ST. LOUIS
WOODWORKS

Project: Webster Science

SUBMITTAL IDENTIFICATION SHEET

WEBSTER UNIVERSITY ISB	
PROJECT NAME	
8274 BIG BEND BLVD	
ADDRESS	
NUMBER	
WEBSTER UNIVERSITY	
OWNER	
CANNON DESIGN	
ARCHITECT / ENGINEER	
Devin Gates	
SUBMITTED BY	
064216-002	
CONTRACTOR / CM SUBMITTAL NO.	CANNON DESIGN SUBMITTAL NO.
	064216
DRAWING / DETAIL REFERENCE	SPECIFICATION SECTION / PARAGRAPH
MANUFACTURER / SUPPLIER	ITEM / PRODUCT ID
REQUIRED DATE	PRIORITY
	CRITICAL

2ND FLOOR

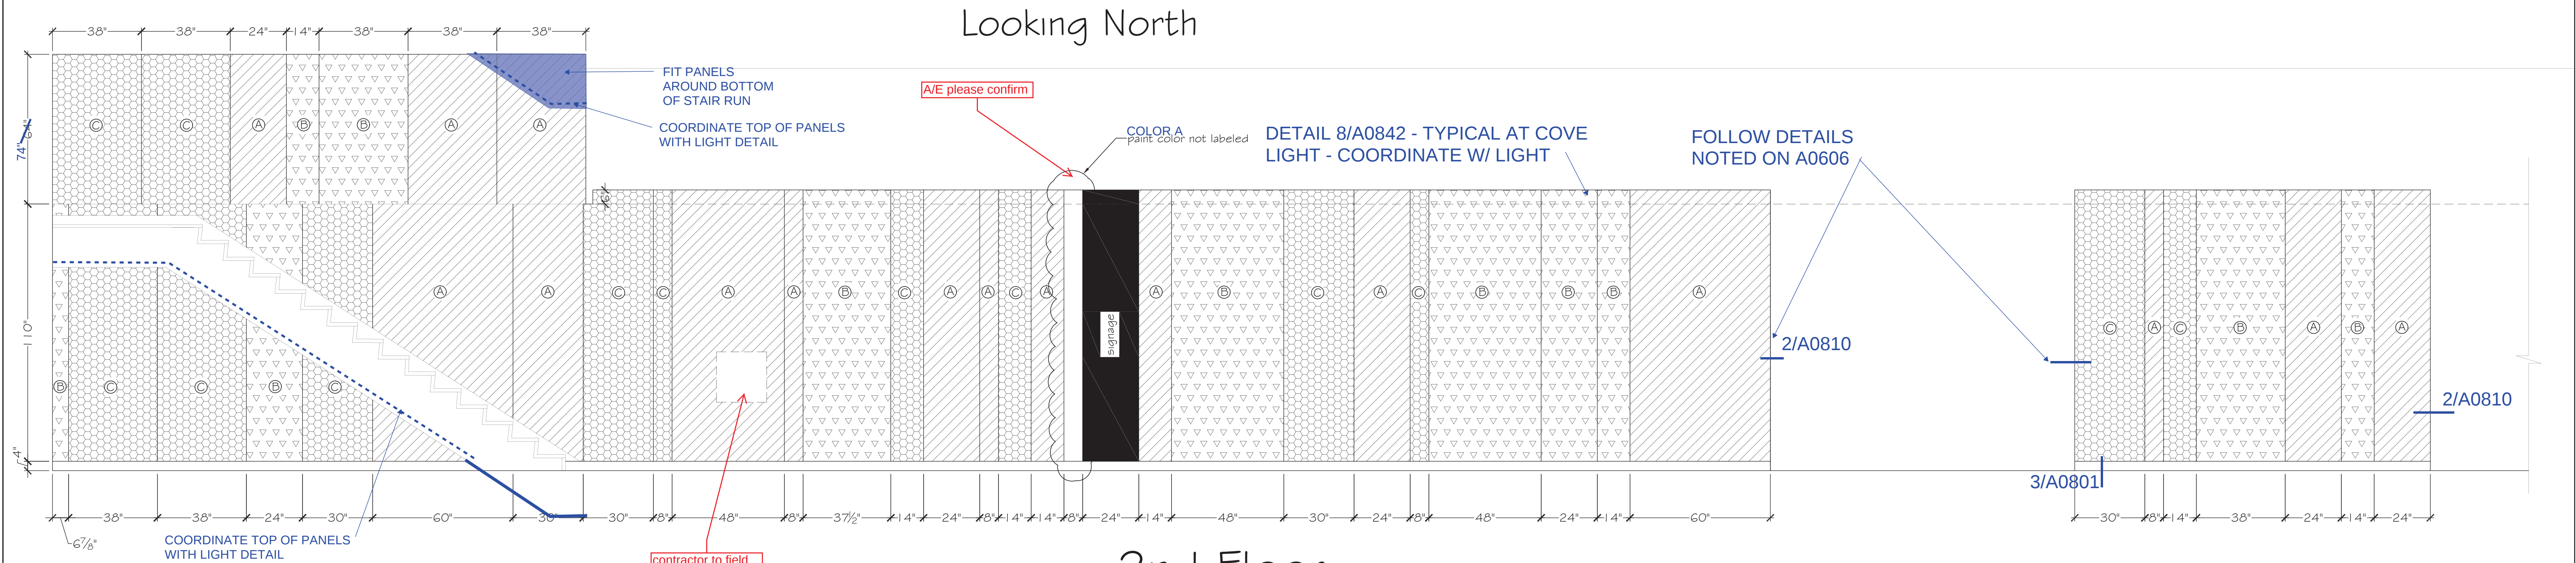
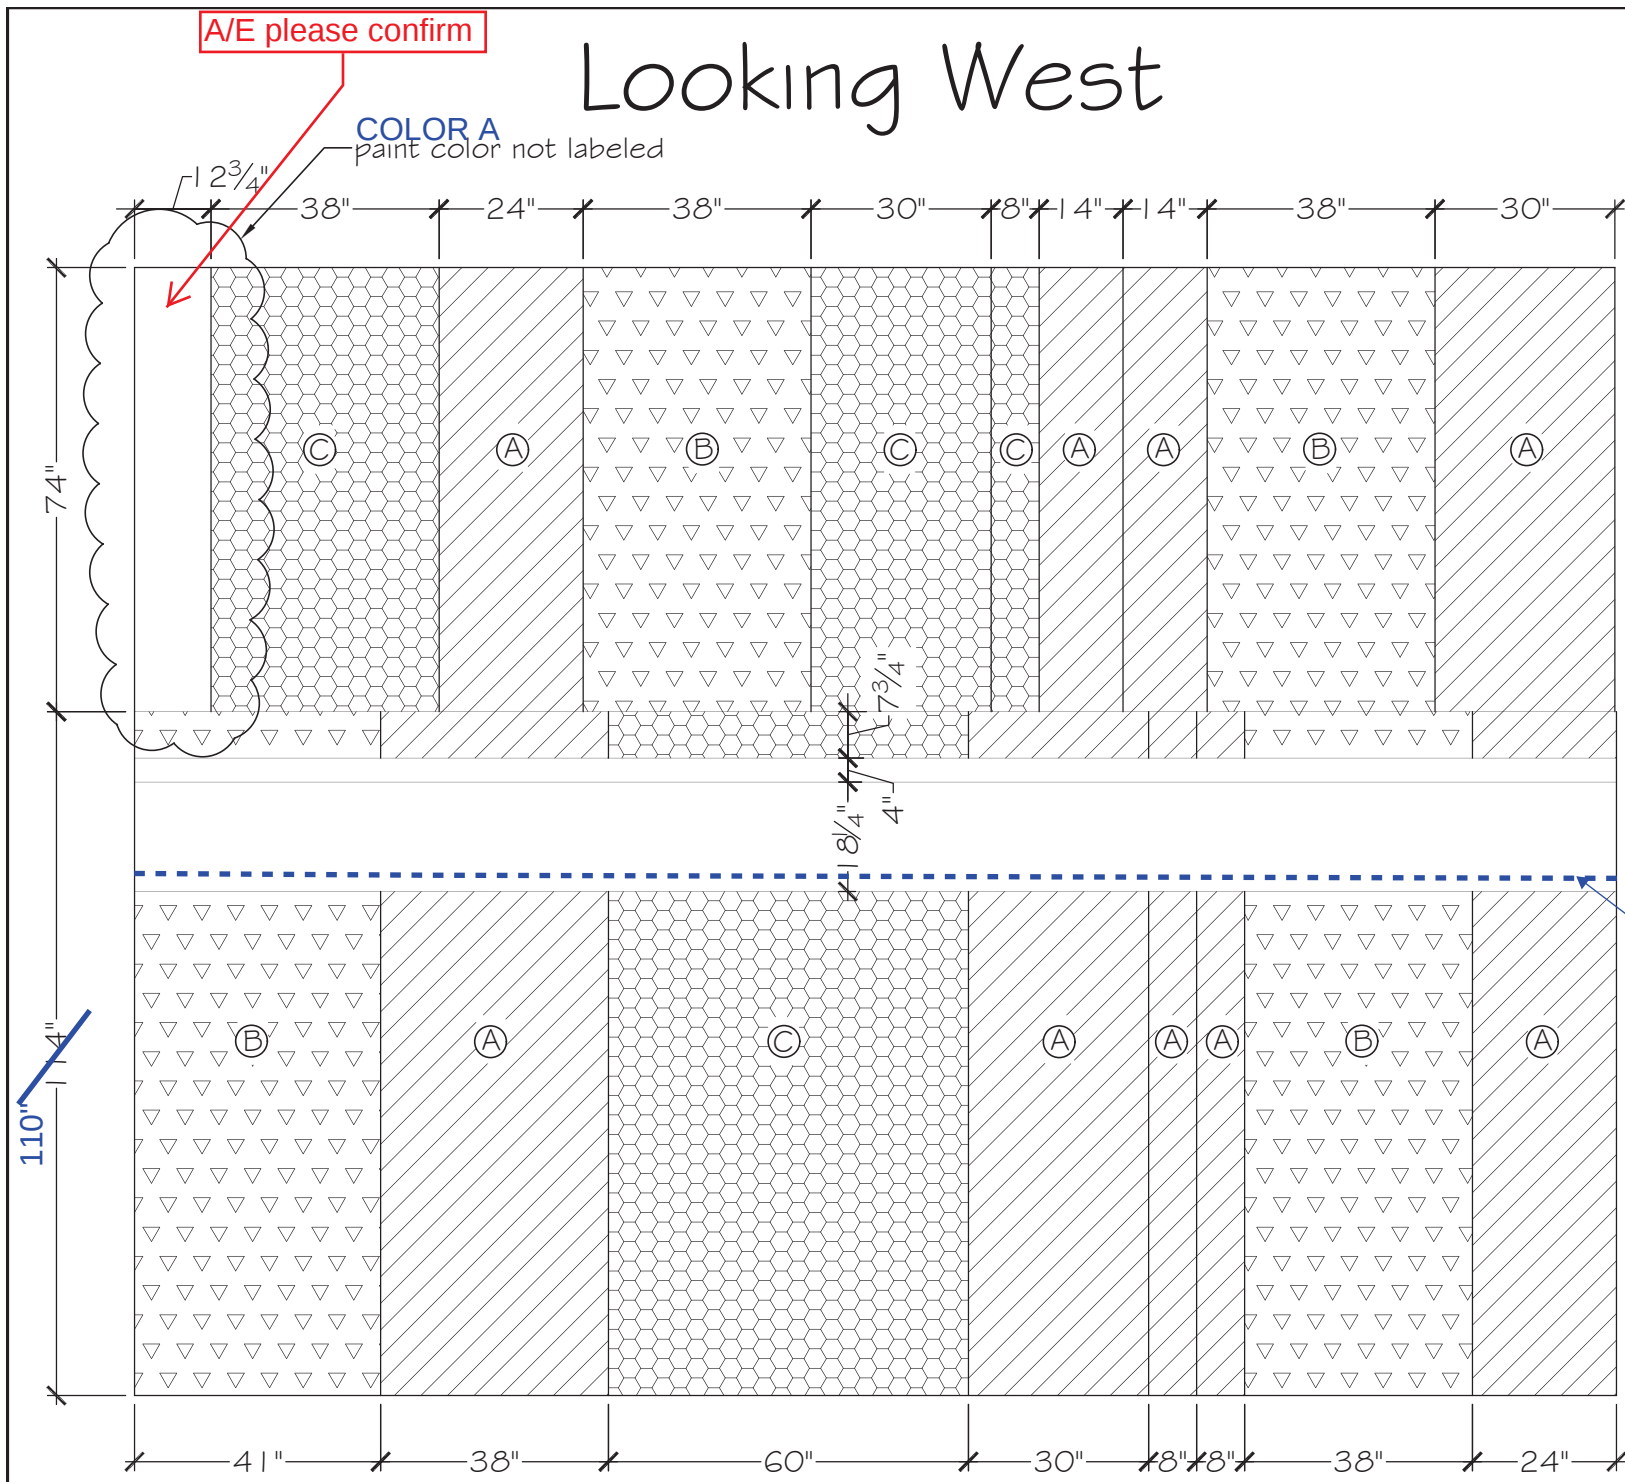
- AE please confirm** (pointing to a clouded area)
- paint color not labeled**
- COLOR A** (pointing to a blue arrow)

COORDINATE TOP OF PANELS WITH LIGHT DETAIL

FIT PANELS AROUND BOTTOM OF STAIR RUN

COORDINATE TOP OF PANELS WITH LIGHT DETAIL

DETAIL 8/A0842 - TYPICAL AT COVE LIGHT - COORDINATE W/ LIGHT

FOLLOW DETAILS NOTED ON A0606

contractor to field

Z-clips at back of
do not extend across
per previous mark

Z-clips at back of panels only,
do not extend across gaps
per previous markup. (TYP)

2nd Floor

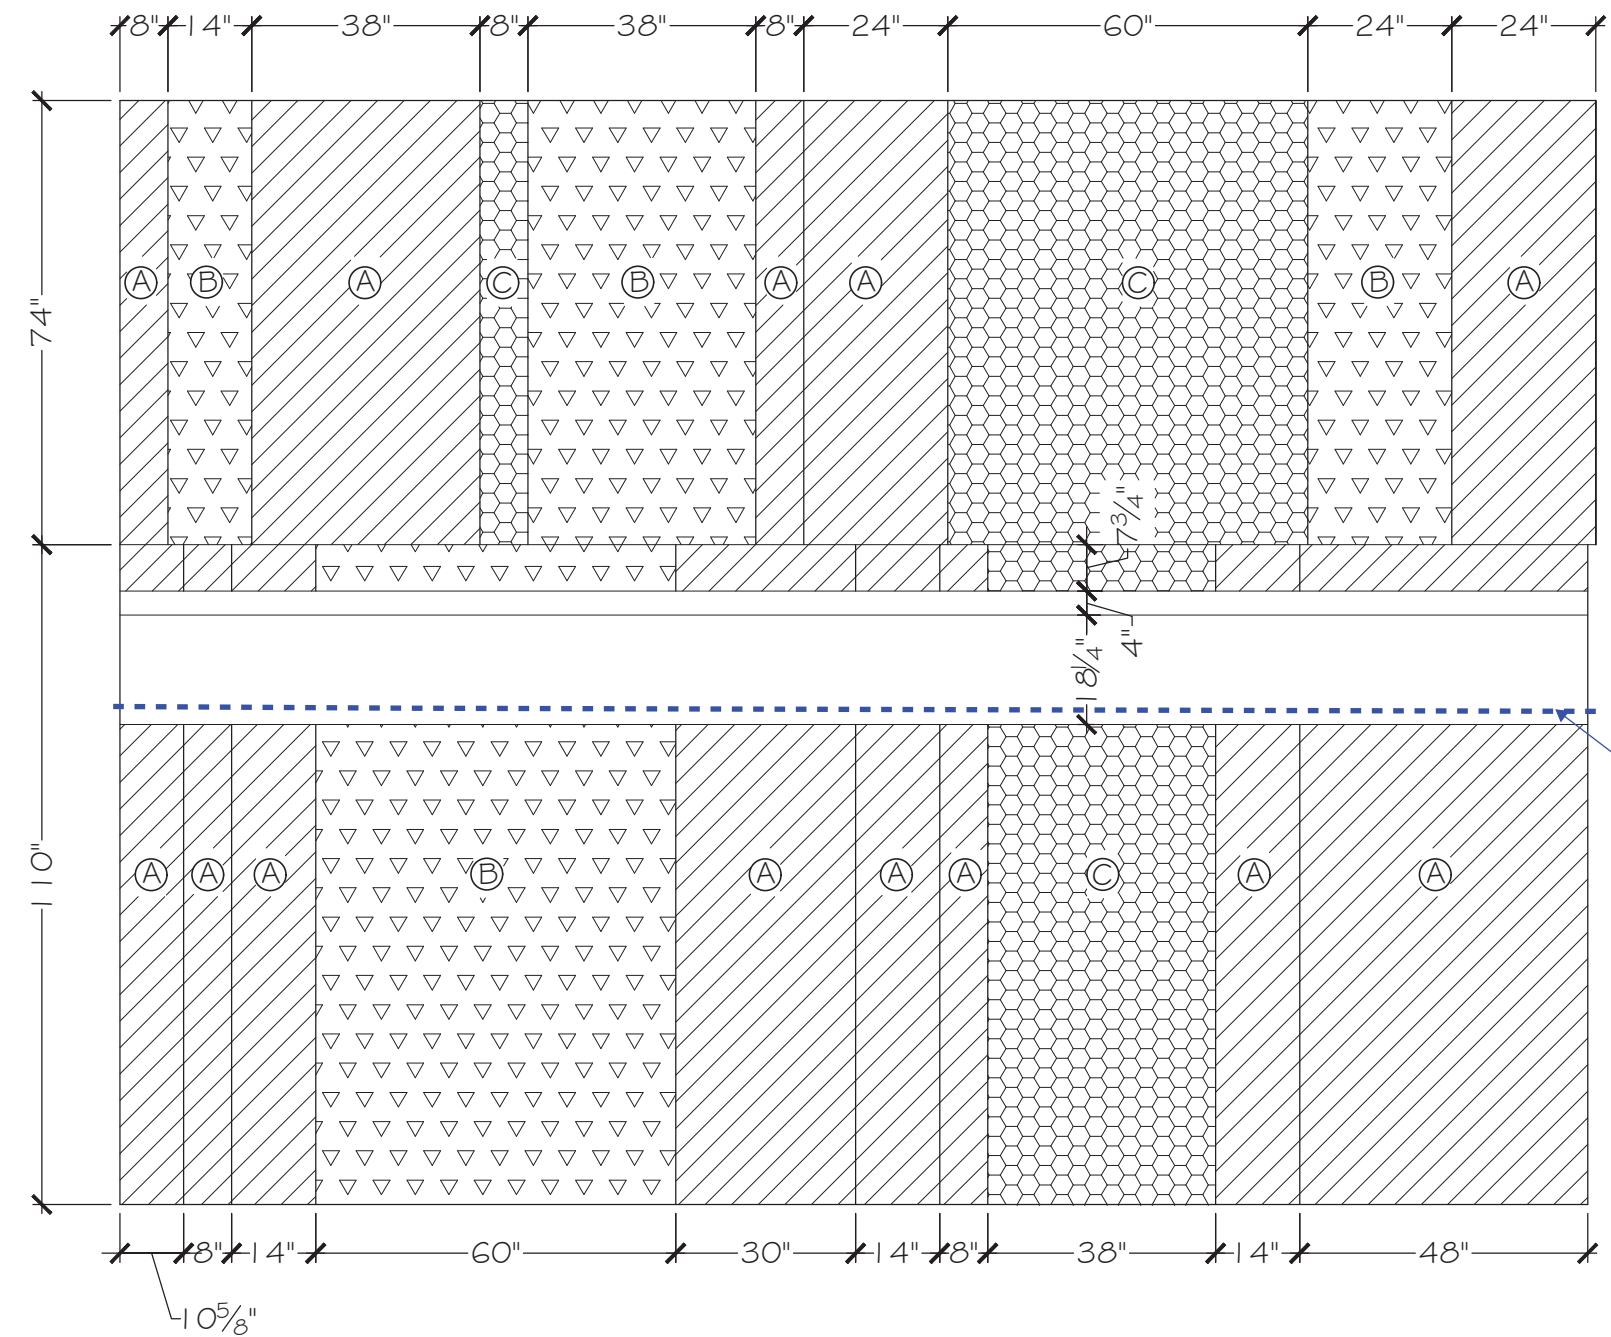
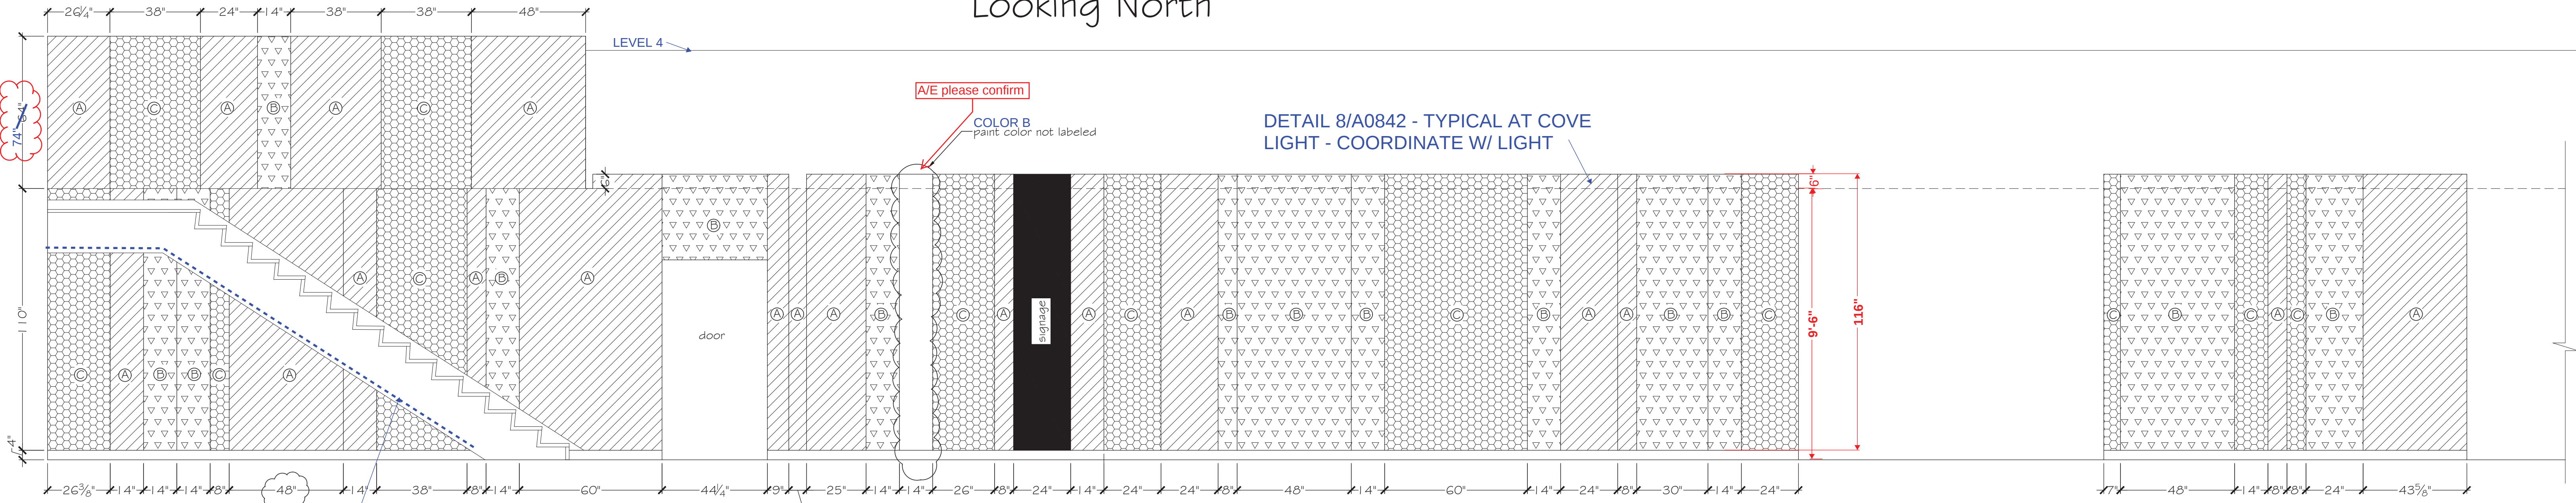
COORDINATE TOP OF PANELS WITH LIGHT DETAIL

A/E please confirm
COLOR B
paint color not labeled

DETAIL 8/A0842 - TYPICAL AT COVE LIGHT - COORDINATE W/ LIGHT

COORDINATE TOP OF PANELS WITH LIGHT DETAIL
